5. Response to Comments

This chapter includes a reproduction of, and responses to, each comment letter received during the public review period on the Draft EIR. Comments are presented in their original format in Appendix K, along with annotations that identify each individual comment number.

Figure 5-1
Alternate Helipad Location

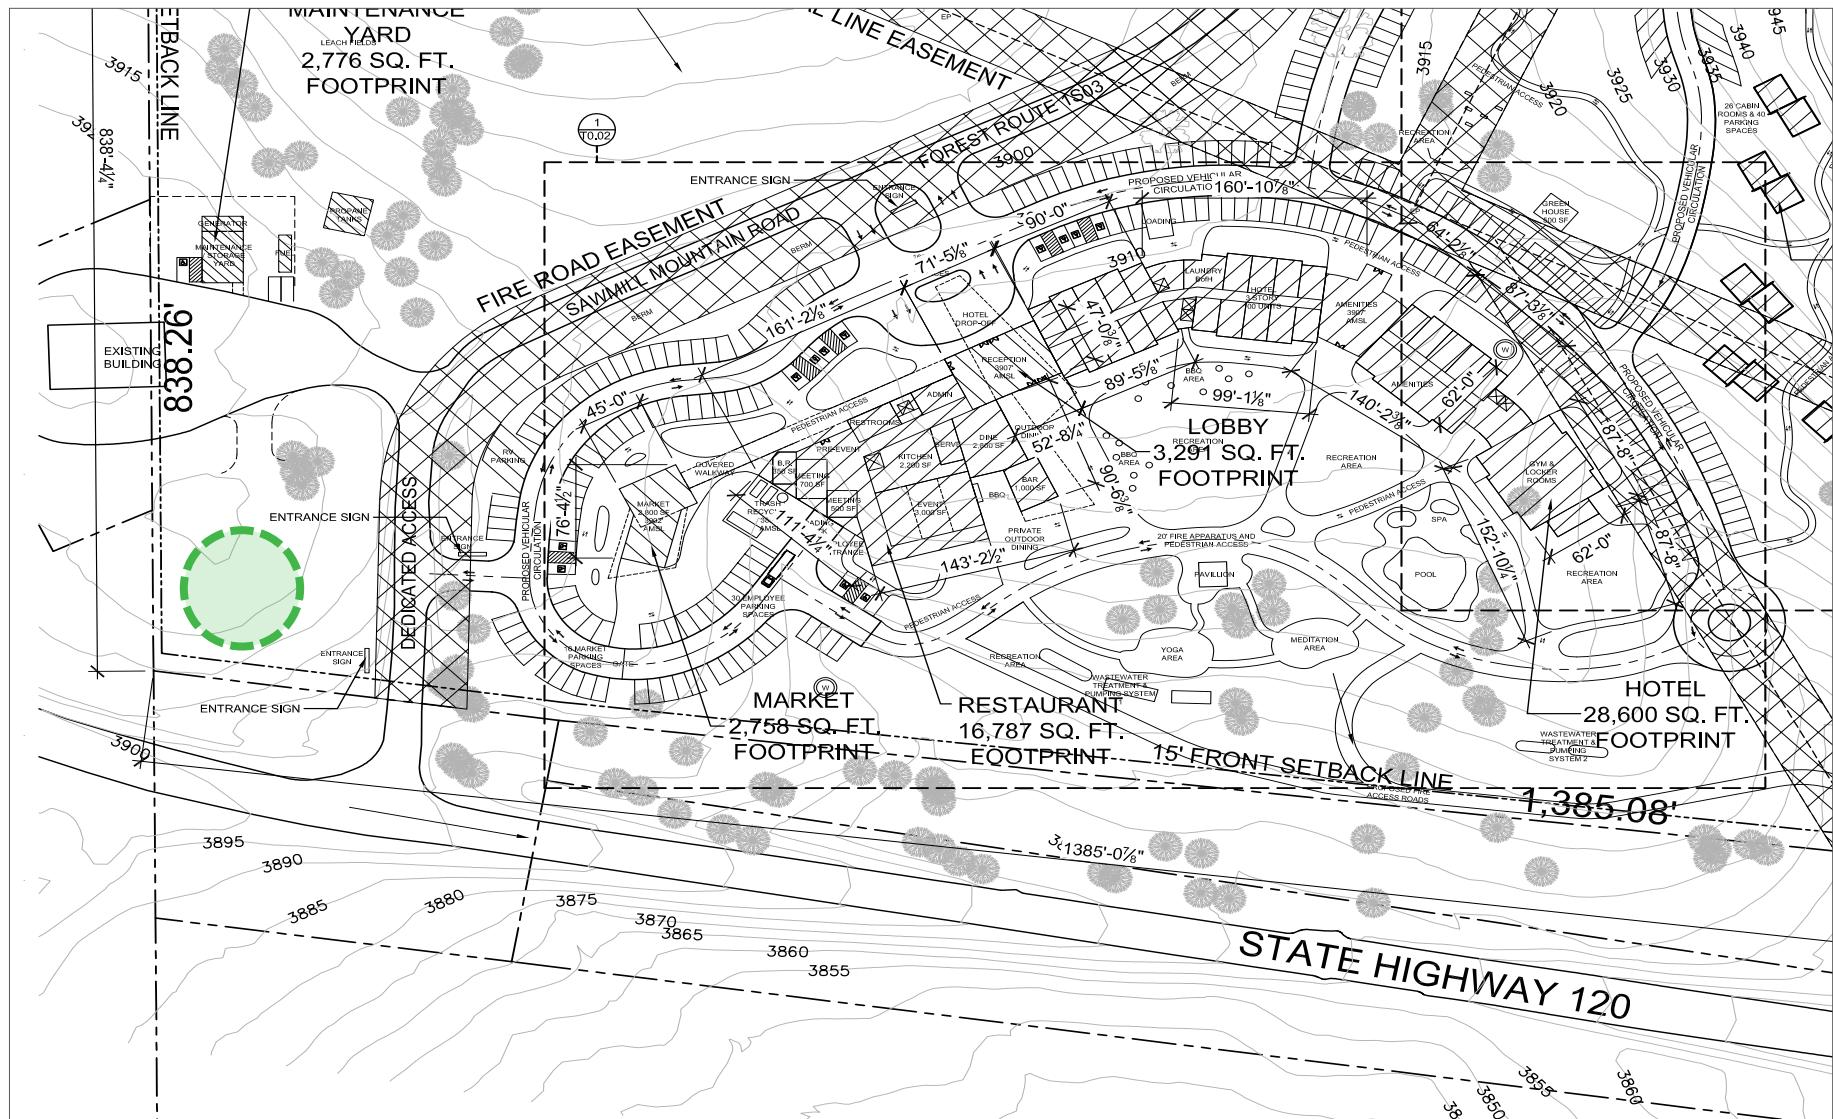
Several comments on the Draft EIR expressed concern about the potential noise effect of the proposed emergency helipad. Mitigation Measure NOI-3.1 has been revised as shown in Table 1-1 and Chapter 3, Revisions to the Draft EIR, to require the project applicant, as part of the design and approvals process for the helipad, relocate the helipad to another area of the project site that is further from residential properties, if feasible. The project applicant has identified a potential alternate helipad location west of

Sawmill Mountain Road, but closer to the intersection of Sawmill Mountain Road with Highway 120 (see Figure 5-1). Potential environmental impacts resulting from the alternate helipad location would be secondary impacts as they would be caused by mitigation and not by the proposed project itself. Potential secondary impacts from the alternate helipad location are discussed below.

Appendix L, Supplemental Noise Analysis, of this Final EIR provides an analysis of helicopter operations at the alternate location shown in Figure 5-1. Based on the results presented in Table 13 of Appendix L, noise levels associated with the alternate helipad location are predicted to result in reduced noise level exposure at over half of the identified existing noise-sensitive uses (receivers 1 to 15). However, noise levels at the alternate helipad location could still result in substantial temporary increases in ambient daytime and/or nighttime noise levels at nearby existing sensitive uses. As with the proposed helipad location analyzed in the Draft EIR, there are no feasible mitigation measures that would ensure that noise impacts would be less than significant. Therefore, the impact would remain significant and unavoidable. Nonetheless, based on the analysis in Appendix L, the alternate helipad location would reduce noise level exposure at a majority of the nearest residential receivers and is therefore recommended as a location that would reduce, but not entirely avoid, noise impacts. Mitigation Measure NOI-3.1 has been revised, as shown in Table 1-1 and Chapter 3, Revisions to the Draft EIR, of this Final EIR, to require the project applicant to relocate the helipad to another area of the project site that is further from residential properties (such as the alternate location shown in Figure 5-1), if feasible.
